DEVELOPMENT
APPLICATION

DRAWING REGISTER

OUR LADY OF THE ROSARY
CATHOLIC SCHOOL
The Entrance

PROJECT NAME :
**OUR LADY OF THE ROSARY
CATHOLIC SCHOOL**

DRAWING TITLE: DEMOLITIONS
DEMOLITION OVERALL GROUND PLAN
PROJECT NAME: OUR LADY OF THE ROSARY CATHOLIC SCHOOL
DRAWING SCALE: 1:250, 1:50 @ A1
PROJECT NUMBER: 1382
STAGE: DA
DRAWING NO: A-0300
REVISION NO: 06

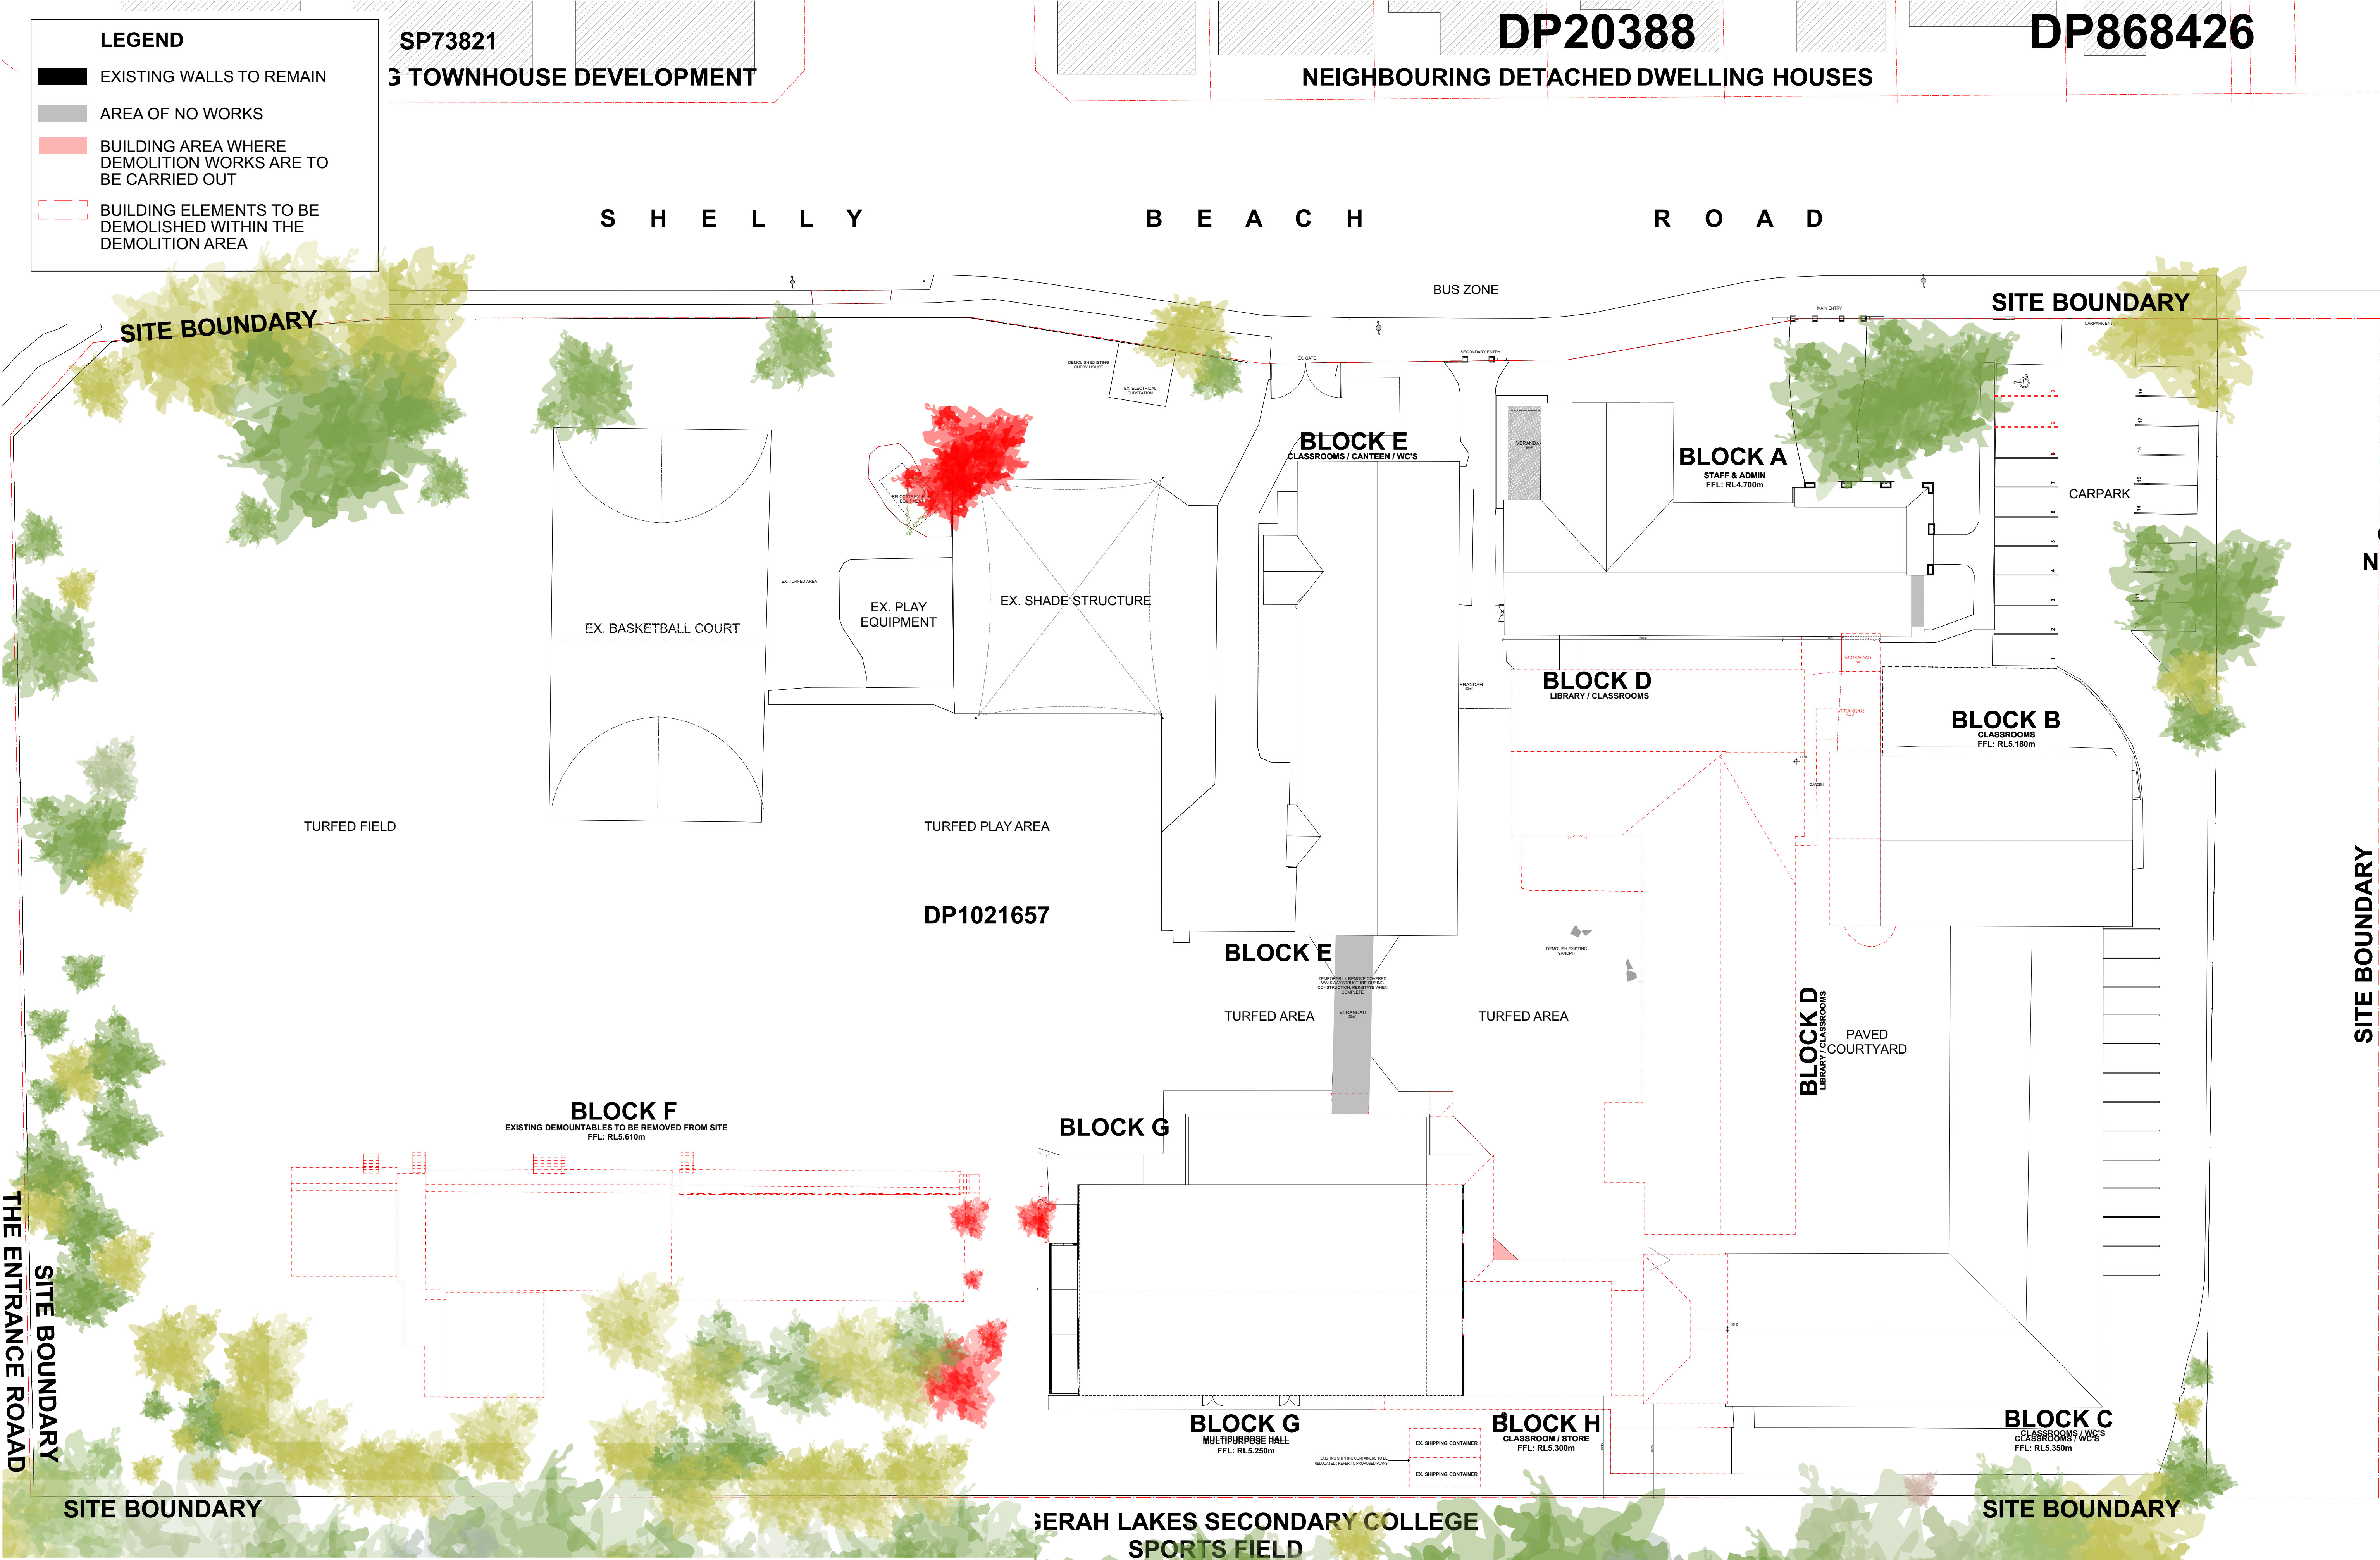
REVISION	CHANGE REGISTER
DA-23	5 TREES TO BE REMOVED TO PROVIDE VEHICULAR ACCESS AS REQUIRED BY NCC 2022 PART S4.3C14

STAGE 1 CONSTRUCTION MANAGEMENT PLAN

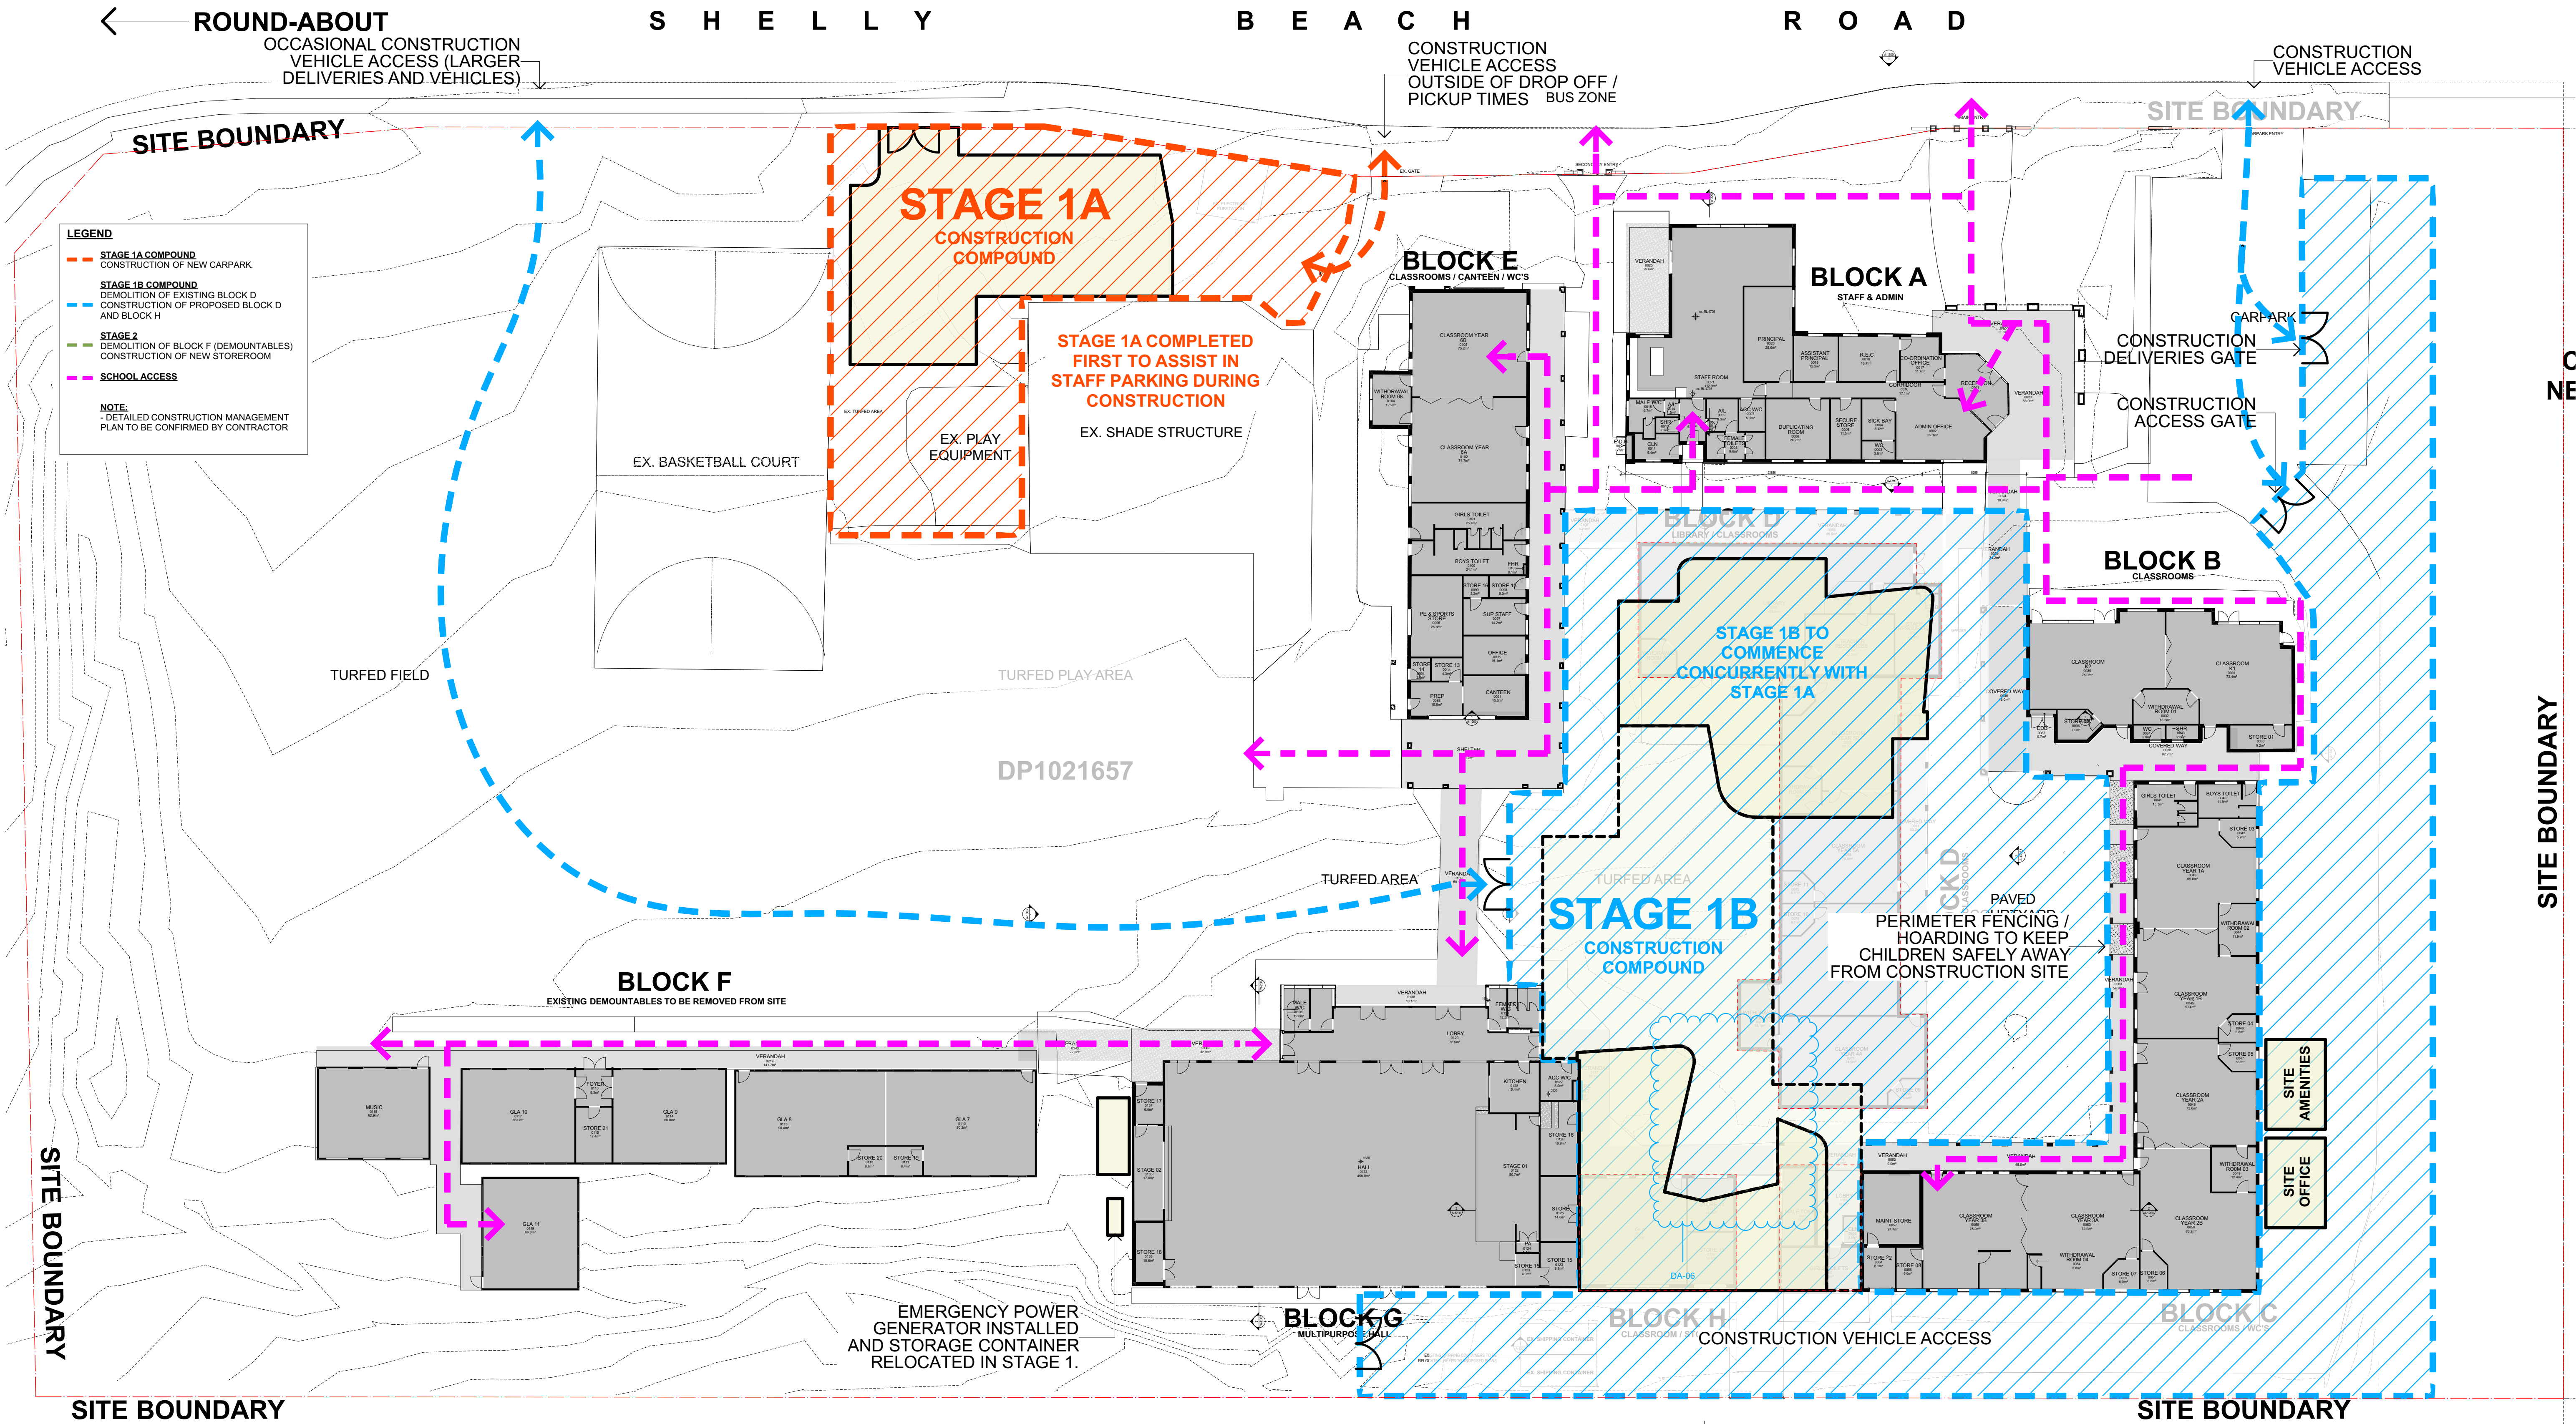
REVISION	CHANGE REGISTER
DA-13	ROOF SHAPE ALTERED TO SUIT REVISED BUILDING FOOTPRINT
DA-06	GLAZED SHARED SPACE EXTERNALISED

DRAWING TITLE:
GA FLOOR PLANS
PROPOSED OVERALL GROUND PLAN
PROJECT NAME:
**OUR LADY OF THE ROSARY
CATHOLIC SCHOOL**

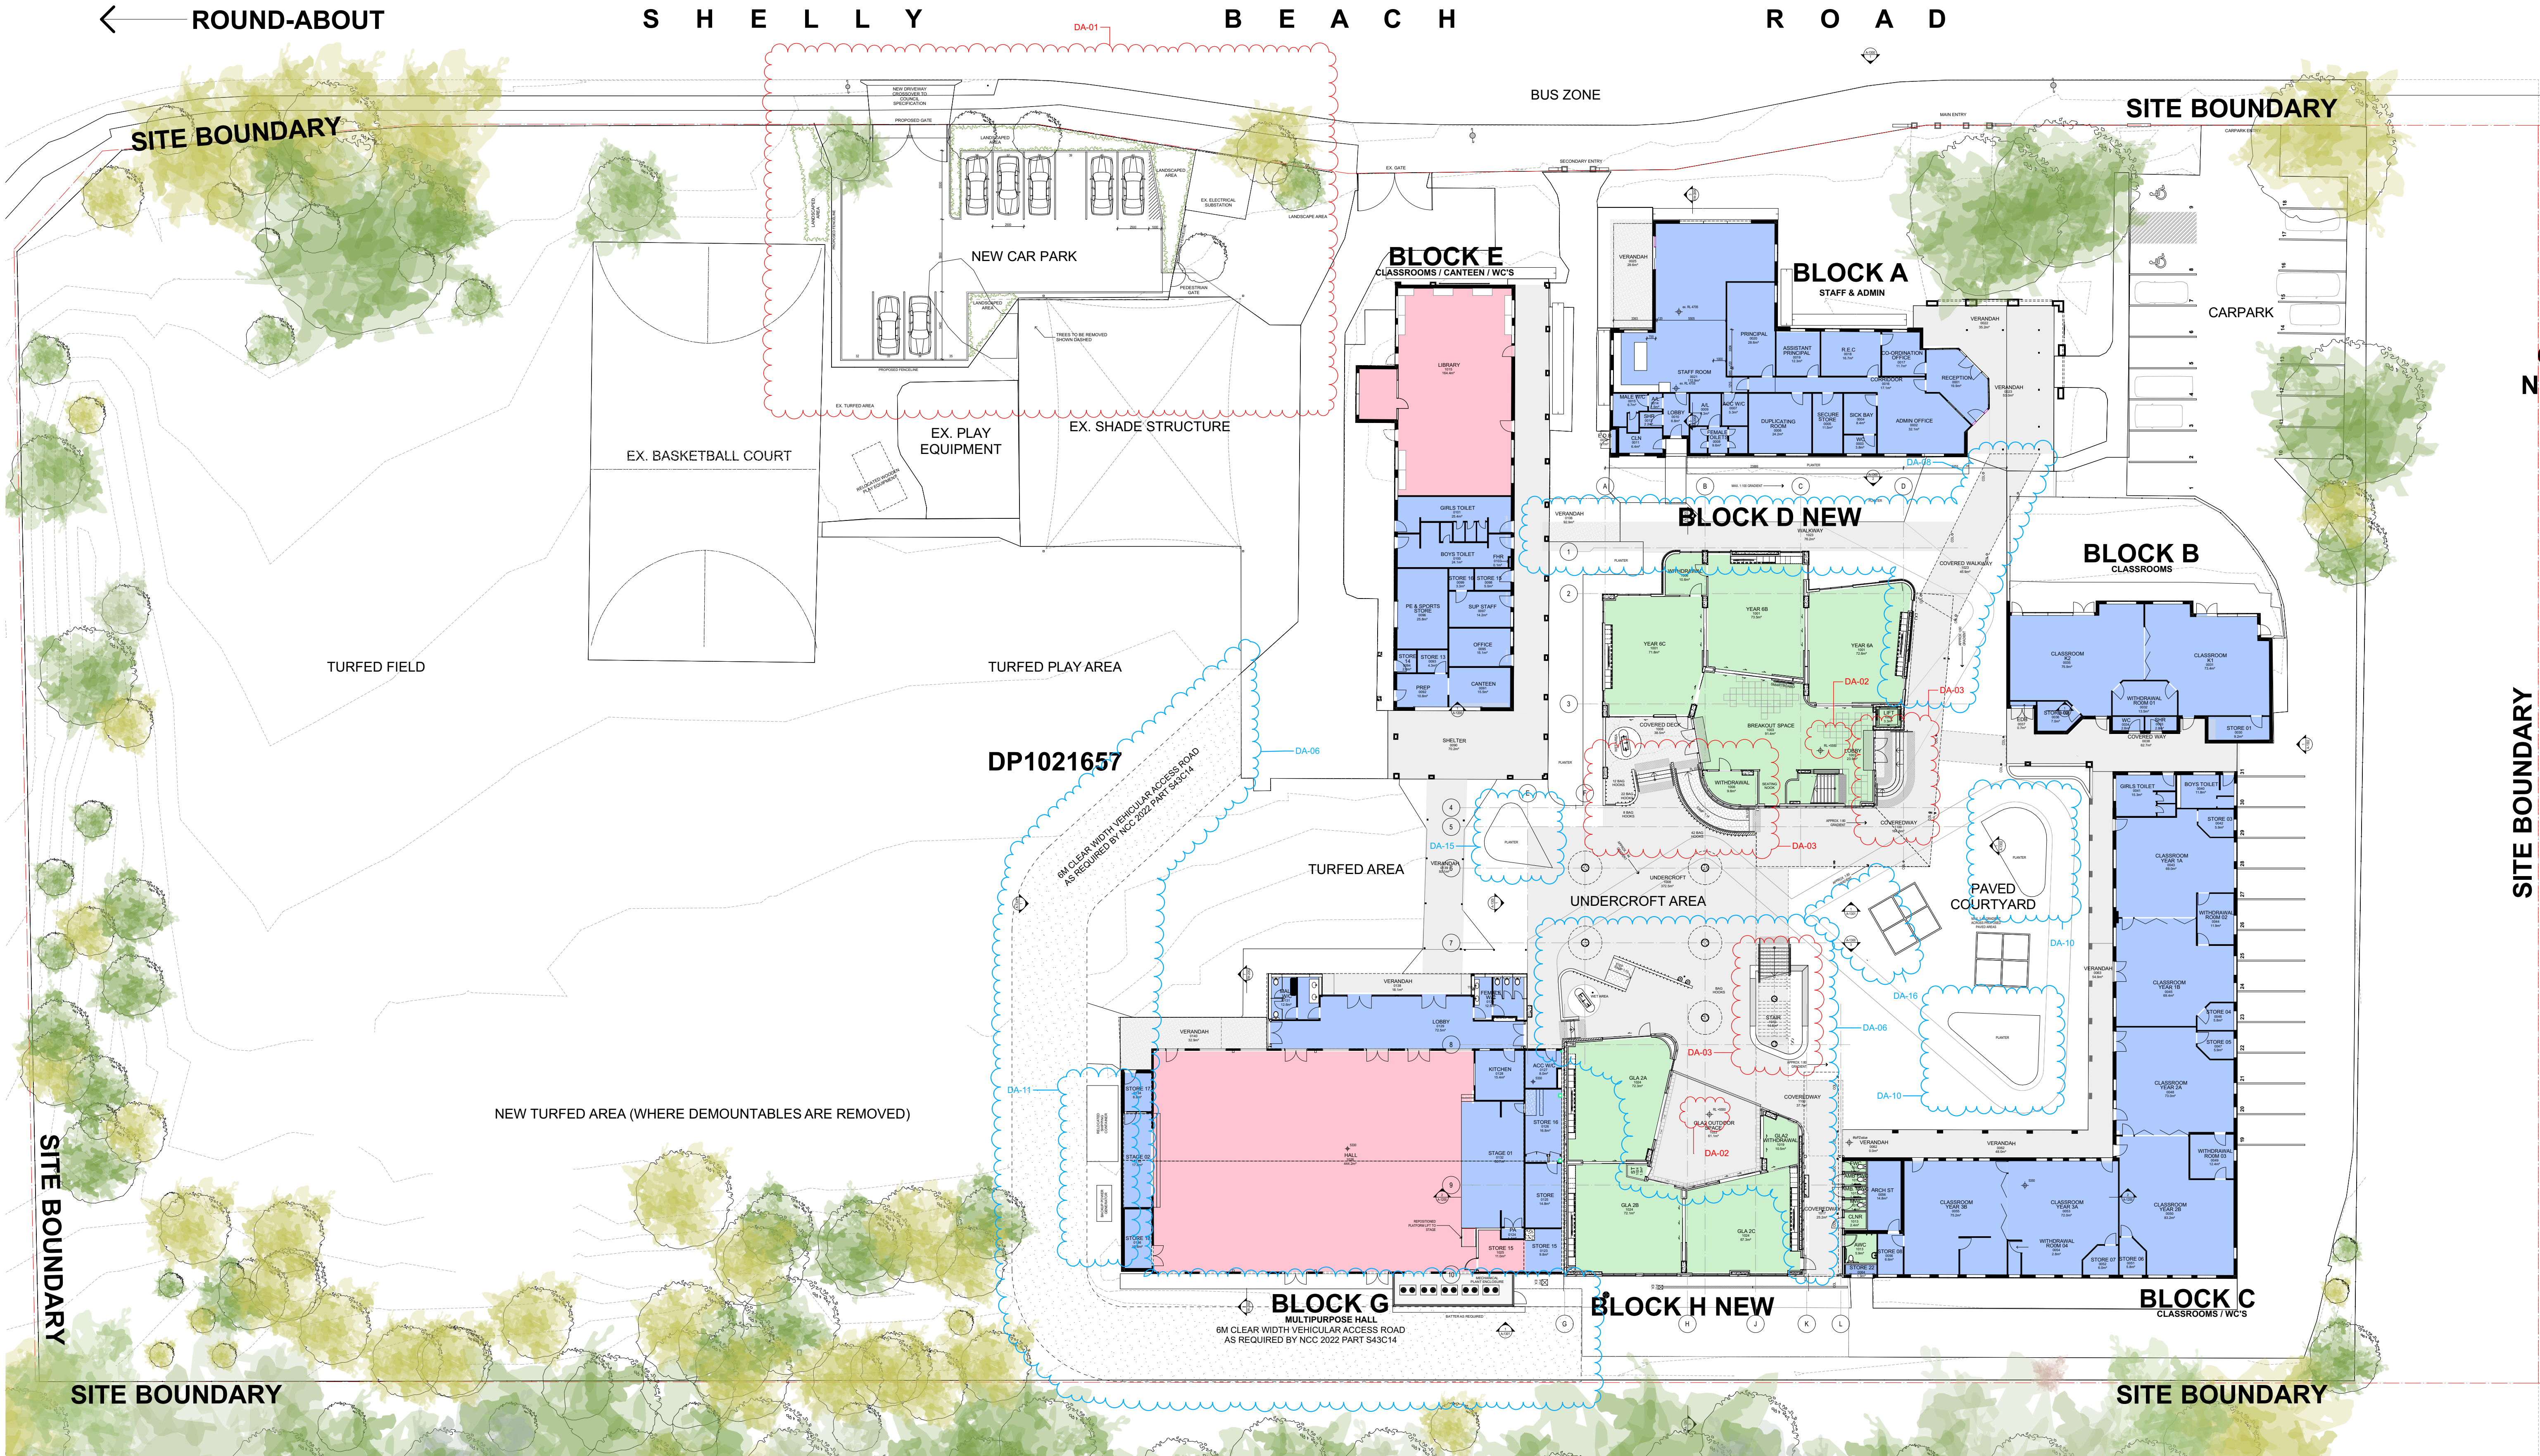
DA-16	GARDEN BED DELETED
DA-15	GARDEN BED ADDED
DA-11	MAINTENANCE STORE DELETED
DA-10	RAISED PLANTER BEDS LOWERED / REDUCED
DA-09	ENTRY CANOPY REDUCED IN SIZE
DA-08	WALKWAY MOVED CLOSER TO NEW BLOCK D
DA-06	GLAZ SHARED SPACE EXTERNALISED
DA-03	STAIRS AND RAMP ADJUSTED TO SUIT NEW FFL
